Access Compliance Report

Public Rights-of-Way

(Curb Ramps)

Intersection ID: 13725	Main Street: AUBURNDALE_RD	Cross Street: N_SHARON_AMITY_RD	Location: NW
ADA ID: A62D390372D5	Ramp Type: Perp	Initial Pass/Fail: Fail	Overall Compliance: No
		Severity Score: 22.5

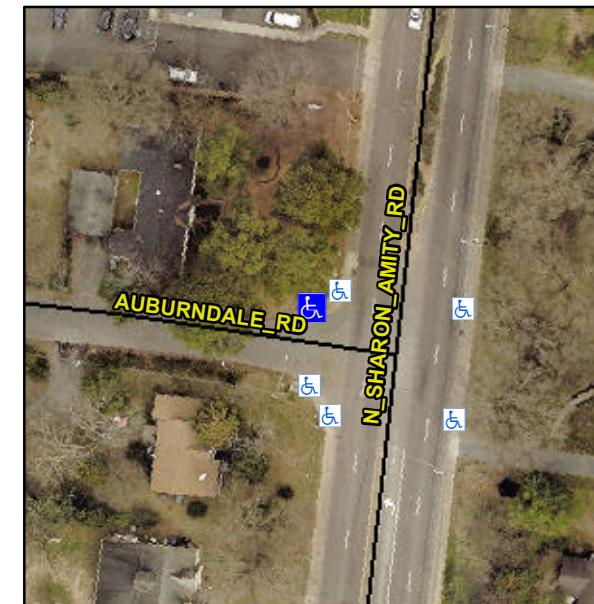
Not Found, R304.5.1, R304.2.2, R304.5.3

Compliance	Description	Data	Compliance	Description	Data
N/A	Ramp Length (in)	59.0	No	Ramp Slope (%)	11.2
No	Ramp Width (in)	44.0	No	Ramp XSlope (%)	4.4
N/A	Flare Type LT	N/A	N/A	Flare Type RT	N/A
N/A	Flare Slope LT (%)	N/A	N/A	Flare Slope RT (%)	N/A
N/A	Flare Traversable LT?	N/A	N/A	Flare Traversable RT?	N/A
N/A	Landing Length (in)	N/A	N/A	DWS Provided?	N/A
N/A	Landing Width (in)	N/A	N/A	DWS Contrast?	N/A
N/A	Landing Slope (%)	N/A	N/A	DWS Length (in)	N/A
N/A	Landing X Slope (%)	N/A	N/A	DWS Full Width?	N/A
N/A	Landing Curb? (Y/N)	N/A	N/A	DWS Offset (in)	N/A
N/A	Shared Landing?	N/A			
N/A	Gutter Ponding?	N/A	N/A	Gutter Slope (%)	N/A
N/A	Gutter Lip Ht (in)	0.5	N/A	Gutter X Slope (%)	N/A
N/A	Painted X Walk1?	No	N/A	Painted X Walk2?	N/A
	X Walk 1 Direction	To S		X Walk 2 Direction	N/A
N/A	X Walk 1 Width (in)	N/A	N/A	X Walk 2 Width (in)	N/A
	X Walk 1 Slope (%)	2.0		X Walk 2 Slope (%)	N/A
	X Walk 1 X Slope (%)	2.1		X Walk 2 X Slope (%)	N/A

Remove & Replace Entire Ramp.
